PERMITPermit Number 09128 **PERMIT ISSUED**Please Read
Application And
Notes, If Any,
AttachedThis is to certify that MARDIGAN STEPHEN /Alba construct NOV 10 2009has permission to Construct 3000 sq ft 2 story building for aAT 745 FOREST AVE CB 130 K001001 City of Portland

City of Portland, Maine - Building or Use Permit Application

**Subject: 757 Forest Avenue – Avenue Auto Co. Automobile Dealership
Owner/Applicant – Stephen Mardigan
Site Plan Amendment Application**

PROJECT NAME: Avenue Auto Co. Automobile Dealership

PROJECT	AVENUE AUTO CO. AUTOMOBILE DEALERSHIP NEW BUILDING CONSTRUCTION PORTLAND, MAINE
SHEET TITLE	AMENDED SITE LAYOUT PLAN
CLIENT	STEPHEN MARDIGAN 480 BAXTER BOULEVARD PORTLAND, MAINE 04103

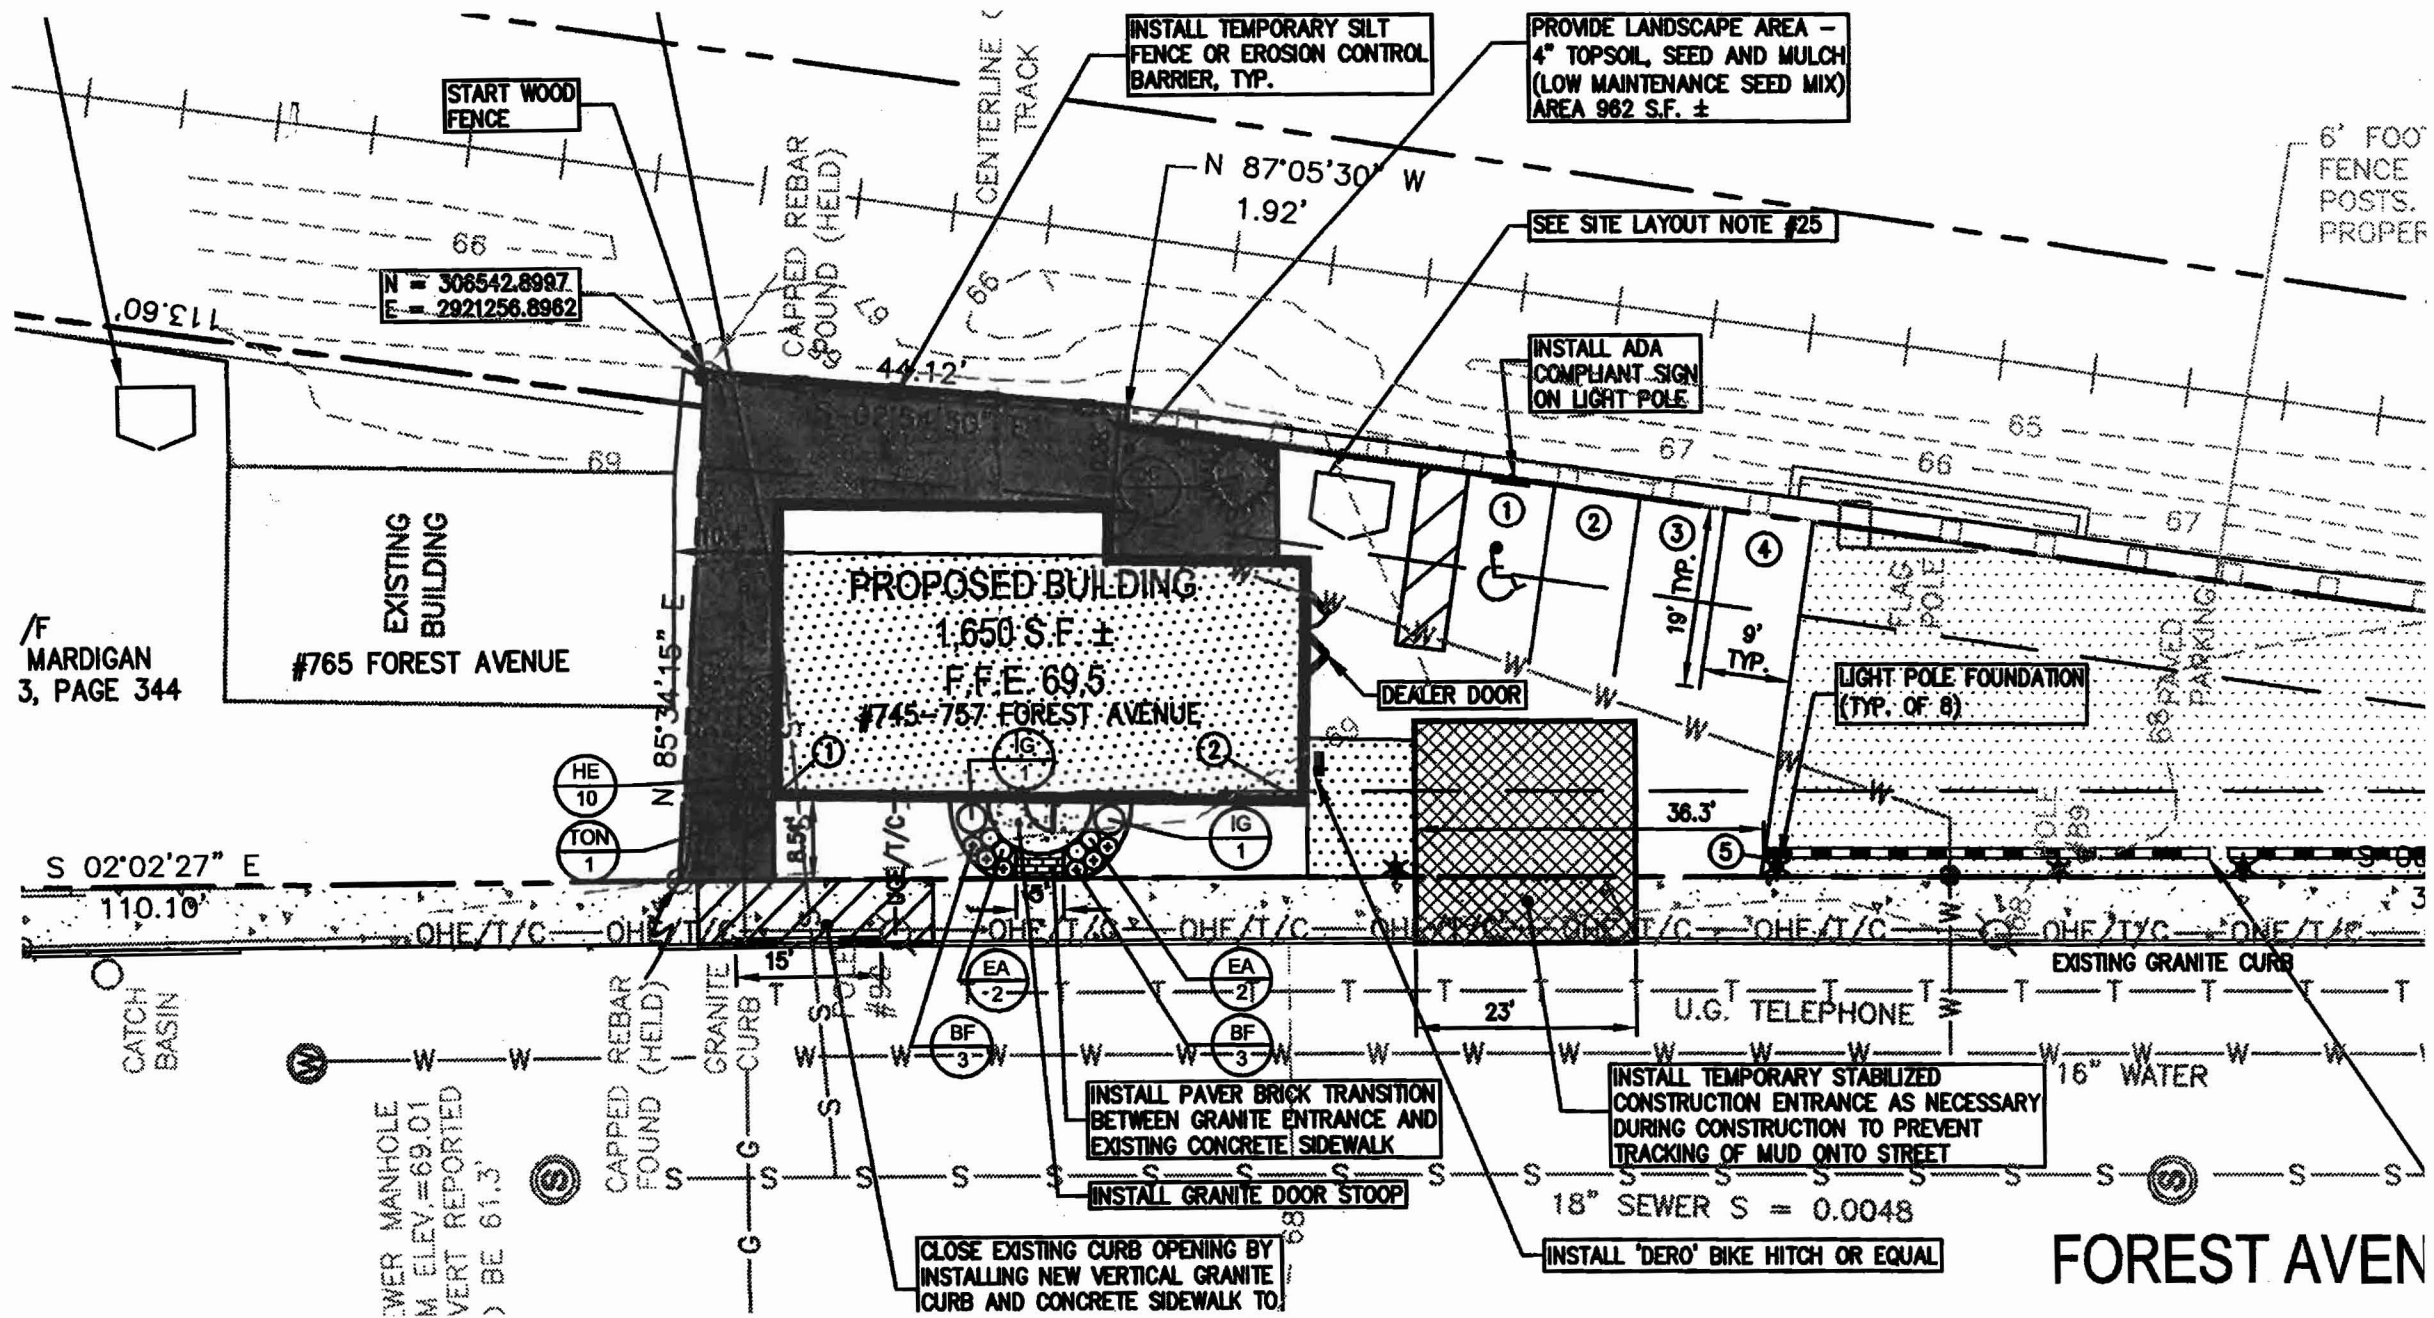
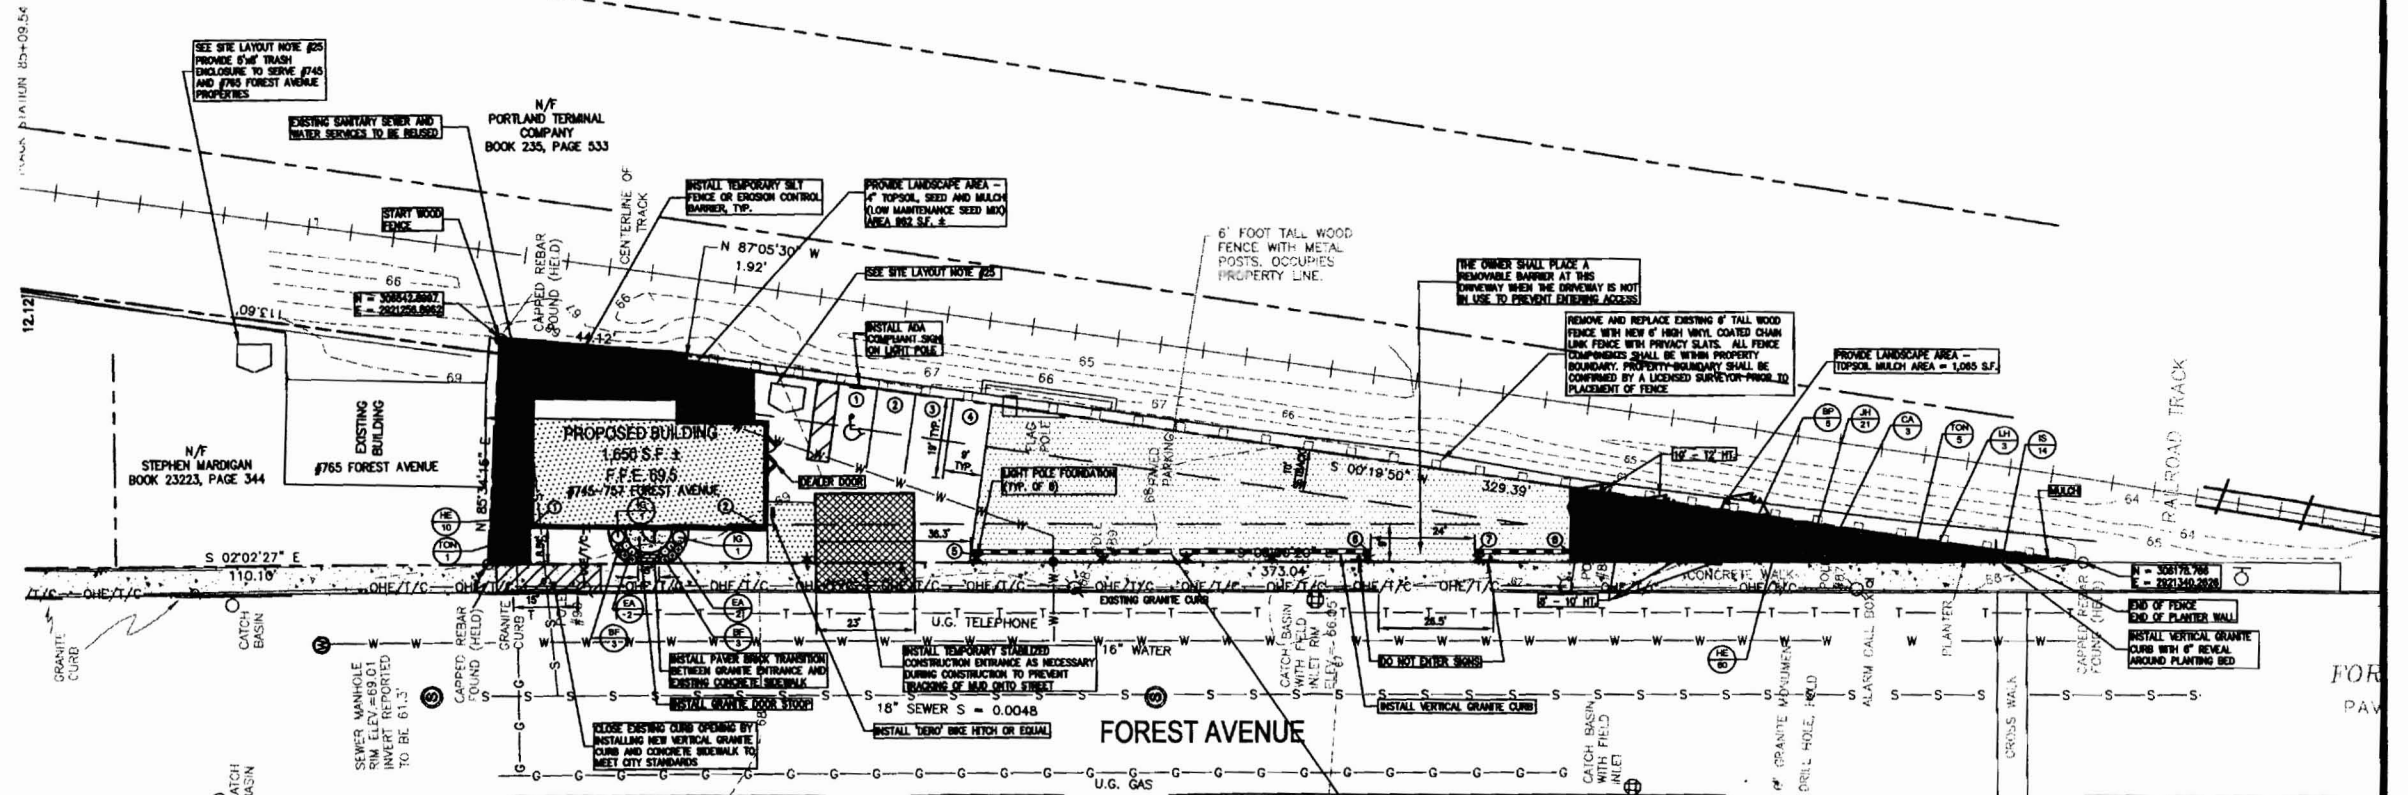
1. The applicant is requesting to realign the proposed building footprint by shifting the layout approximately 3.5 feet southerly and away from the existing building on the neighboring lot. The building shift will result in a separation of approximately 10.4 feet between the buildings. The shift will continue to adhere to the required building setbacks including a 10-foot rear setback. The front of the building will be offset from the front R.O.W. line by approximately 8.5 feet, which is the same as the originally-approved site plan. This shift impacts the category of fire rating for the building wall materials and glazing and will result in construction costs savings.

2. The applicant has eliminated a dealer door along the Forest Avenue building frontage and he is proposing a single standard entrance door along the front. The entrance walk from the door to the existing concrete sidewalk on Forest Avenue will include a granite step in front of the door and a 5-foot-wide paver stone walk connection between the step and the sidewalk. Landscaping beds will be provided on each side of this entrance walk. As a result of these changes, we have also eliminated the granite curb that was to have been placed between the building and the back of the existing sidewalk, as it would not serve any purpose. The dealer door at the south side of the building will remain to allow vehicles to be taken in/out of the building for display. Overall, the level of impervious surface on the site will remain below 80%.
